Rezoning Application: PD 22-1390
Zoning Hearing Master Date: June 20, 2023
BOCC Land Use Meeting Date: August 8, 2023

APPLICATION NUMBER: PD 22-1390

DEVELOPMENT REVIEW STAFF REPORT

8.0 PROPOSED SITE PLAN (FULL)

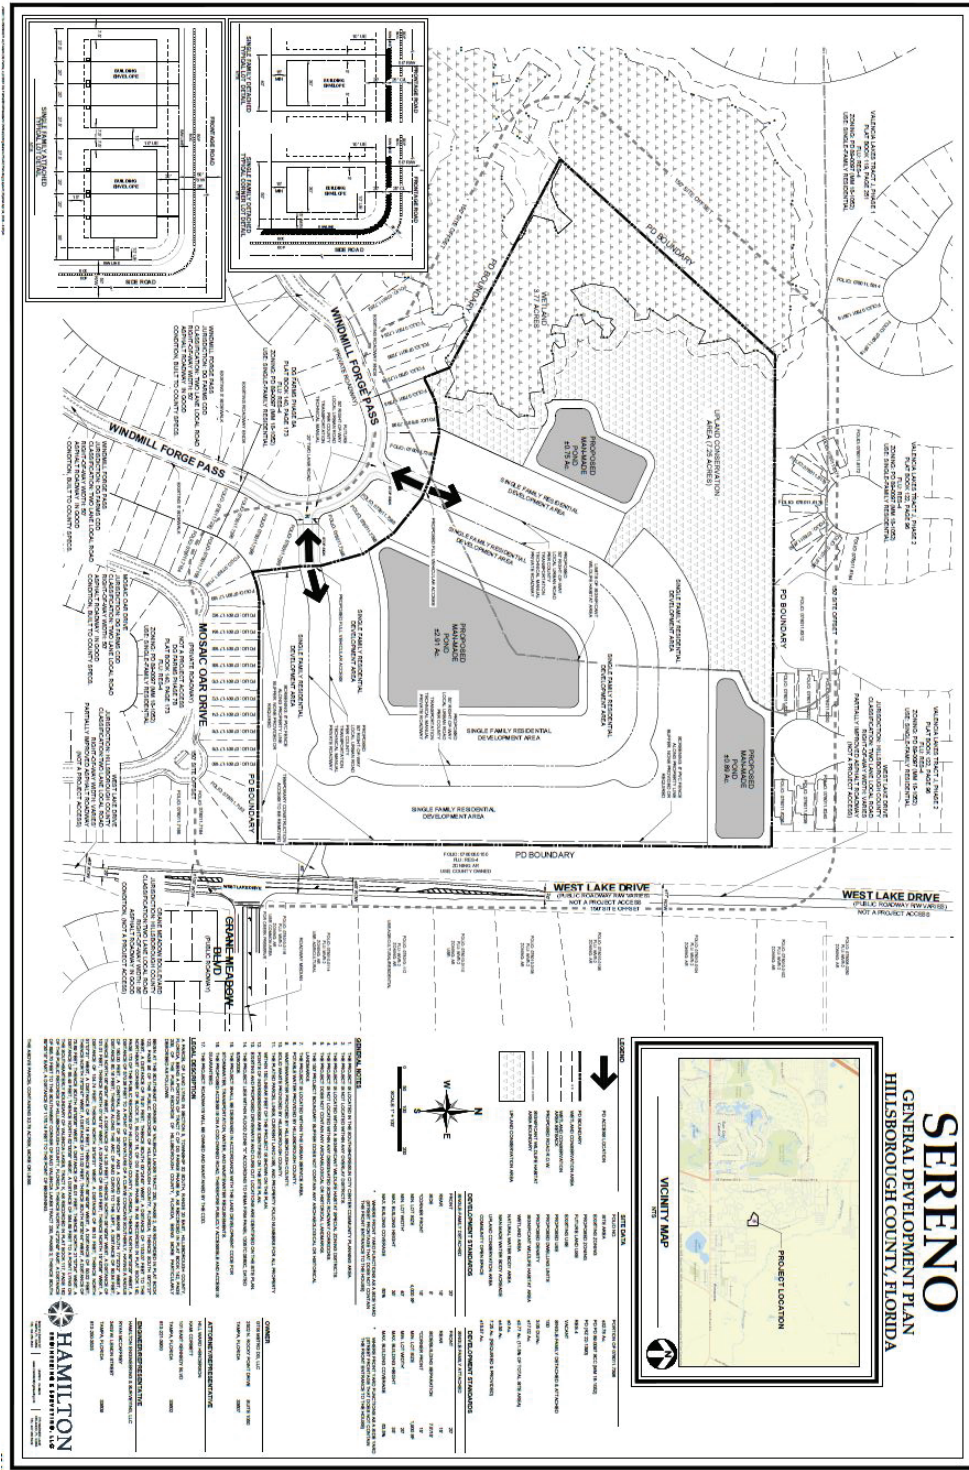
- 1. Maximum building coverage to be removed for both lot types.
- 2. Add a note that reads "Sidewalks to be provided per the Hillsborough County Land Development Code."

GENERAL DEVELOPMENT PLAN HILLSBOROUGH COUNTY, FLORIDA

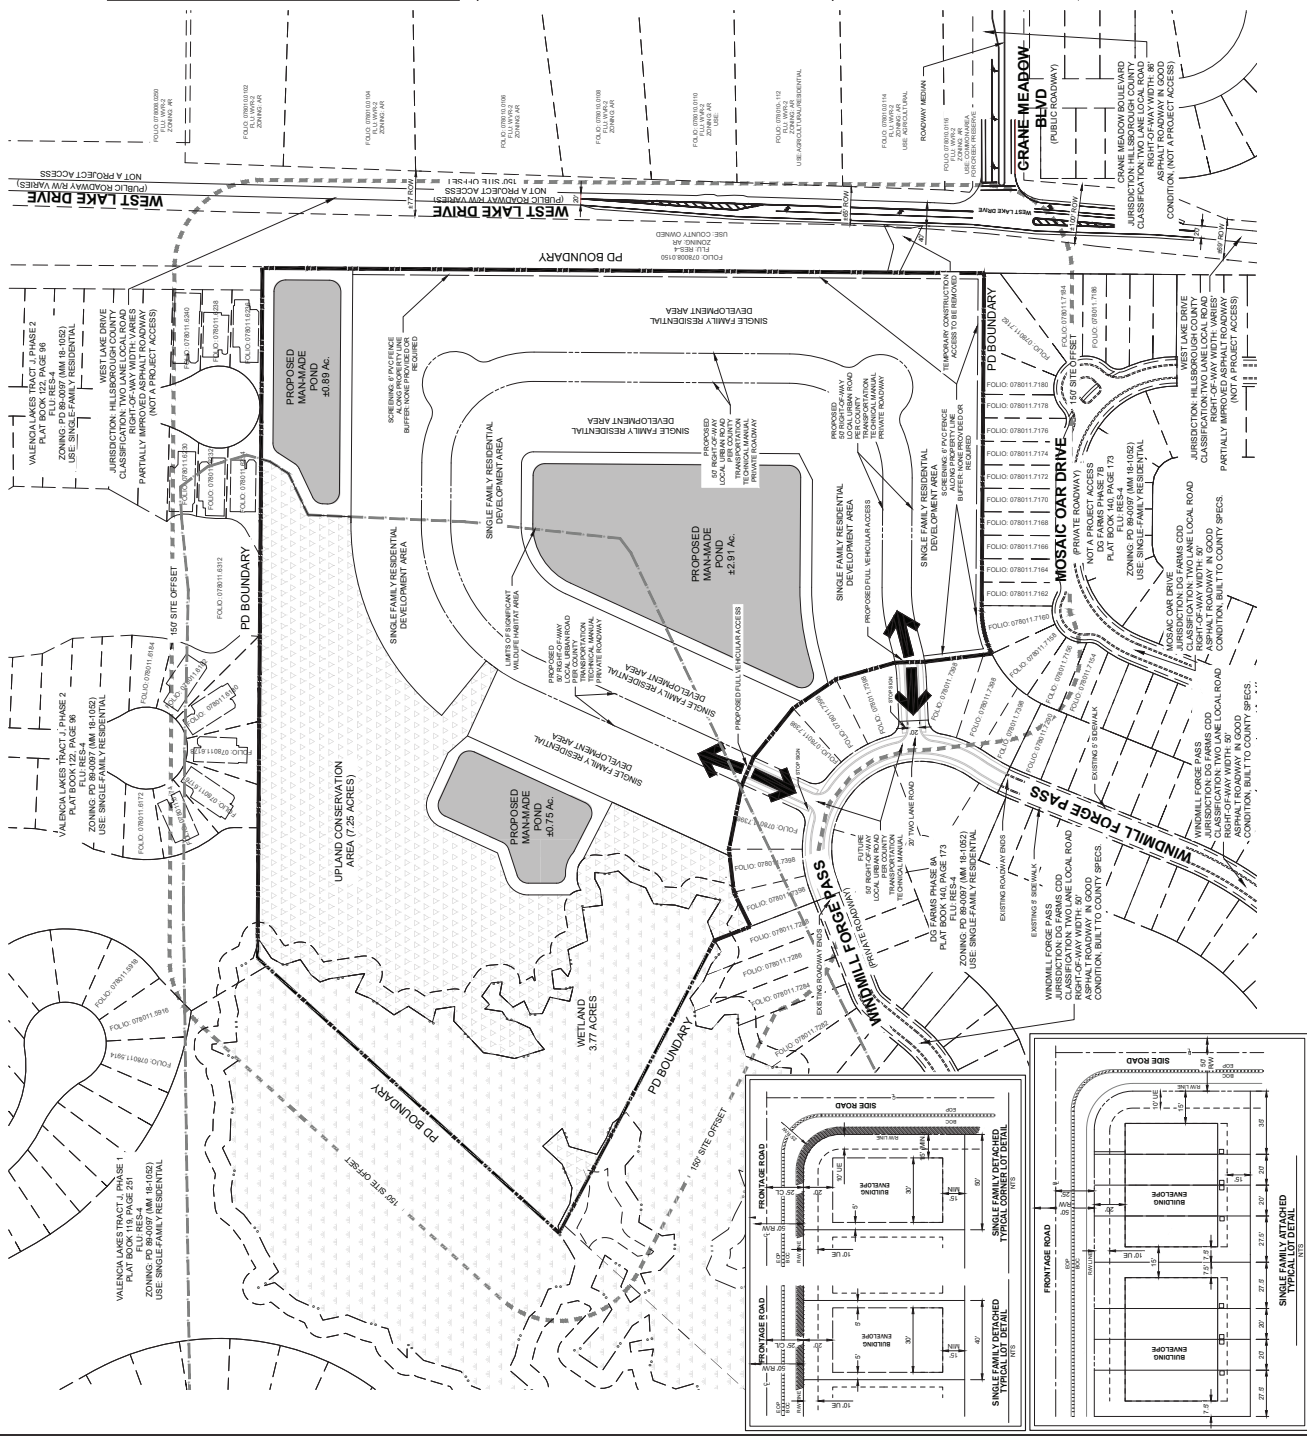
1. The proposed location of the 7.25 acres of Upland Conservation Area as shown on the plans submitted on April 24, 2023, is acceptable with the exception of the area located between proposed lots. This square footage will need to be incorporated into the main conservation area to maintain the minimum acreage requirement for conservation.

Additionally, recent aerial images indicate that a portion of the mapped Significant Wildlife Habitat area on this site has been disturbed. This area will either need to be restored, or will be subtracted from the acreage that will credit toward the required acreage to be preserved. This will be determined during the construction plan review, and may result in additional adjustments to the location of the Upland Conservation Area and the number and location of proposed lots.
